1968 Corvette: Chevrolet Engineering Memo: Window Service Update

Subject: Window Service Update
Model and Year: 1968 Corvette
Source: Chevrolet Engineering Memo - Mr. G. H. Tyler of Chevrolet Engineering
Page Number: NA
Date: March 1968

MISC . Information from Mr. G. H. Tyler of Chevrolet Engineering

GLASS ADJUSTMENT PROCEDURE

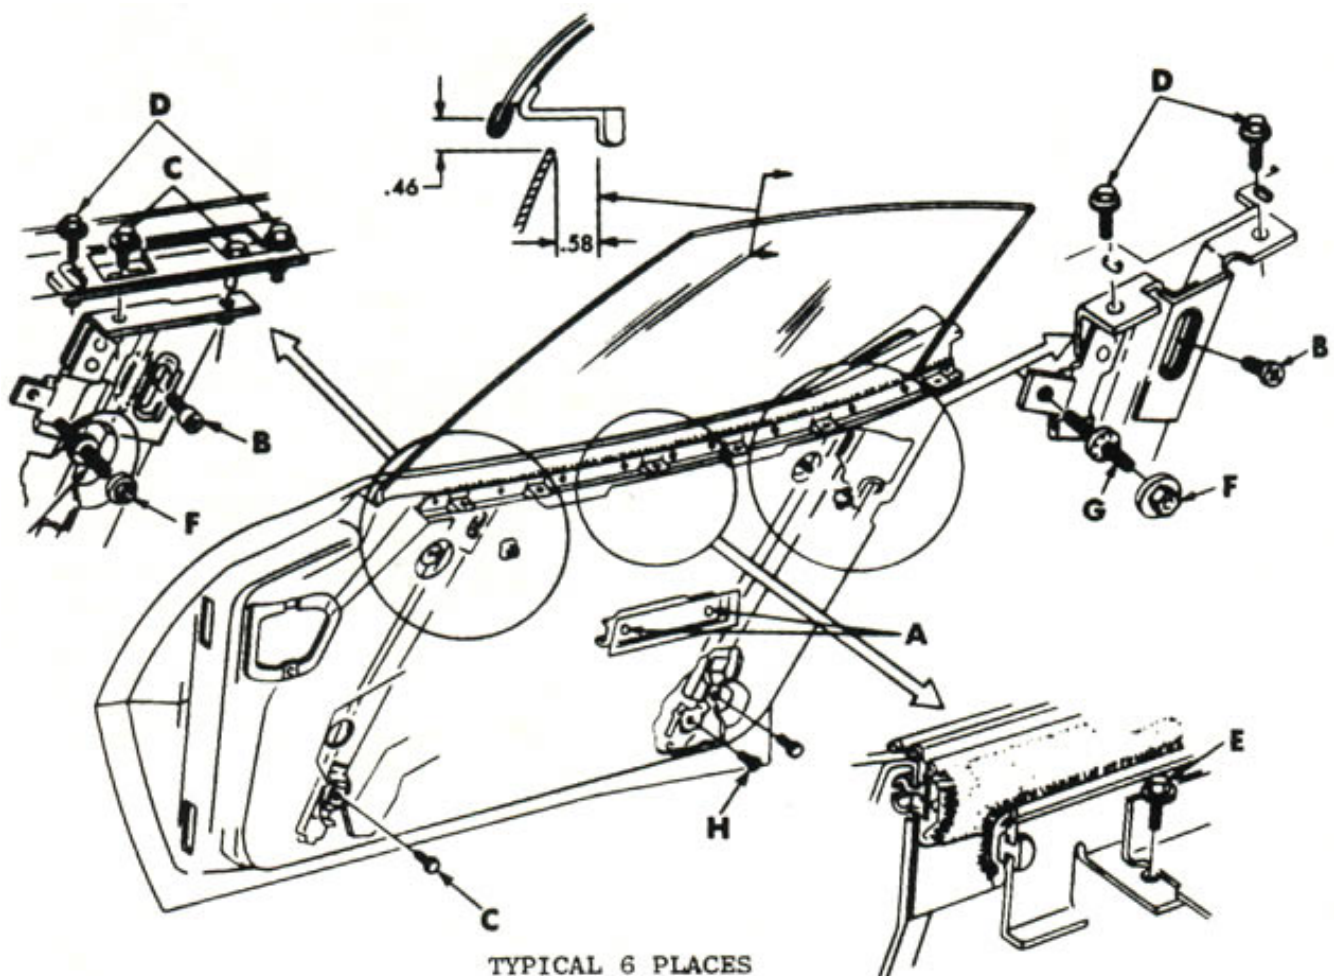
The adjustment procedure for 1968 Corvette door window glass has been revised as of this date. Items No. 3 and 4 have been revised.

1. Loosen bolts (A) and adjust the fore and aft tilt of the door window glass by rotating until a constant gap, or relationship, is obtained between the front edge of glass and the windshield pillar. Retighten bolts (A).
2. Loosen the front and rear stop screws (B) and roll glass up until top edge is .46 below roof rail. Move front and rear stops to contact the window rollers. Retighten screws (B).
3. Loosen the 3 bolts (C) and front nut (F) and slide door glass forward so that the front edge is .44 from and parallel to the windshield pillar. Retighten bolts (C).
4. Loosen bolts (D), (E) and rear nut (F). move bailey weatherstrip outboard so outer nylon pads are in contact with door outer panel reinforcement. Retighten bolts (E). move glass run channel so the top

of the glass is .58 from the vertical flange of the roof rail (move the glass run channel outboard to move the upper edge of glass inboard, move the glass run channel inboard to move the upper edge of glass outboard.) Retighten bolts (D).

5. Turn adjusting screw (G) so the front and rear inner nylon pads are in light contact with the wedges. Tighten nuts (F).
6. Loosen screw (H) and roll glass down until top edge is flush with door outer panel. Move stop to contact the window roller. Retighten screw (H).
7. Install and adjust windshield pillar weatherstrip, front rail weatherstrip, center rail weatherstrip, and rear rail weatherstrip to seal on glass.

Above procedure pertains to Assembly Plant operation. For Service, remove weatherstrip, weatherstrip retainer and door trim panel prior to glass adjustment.
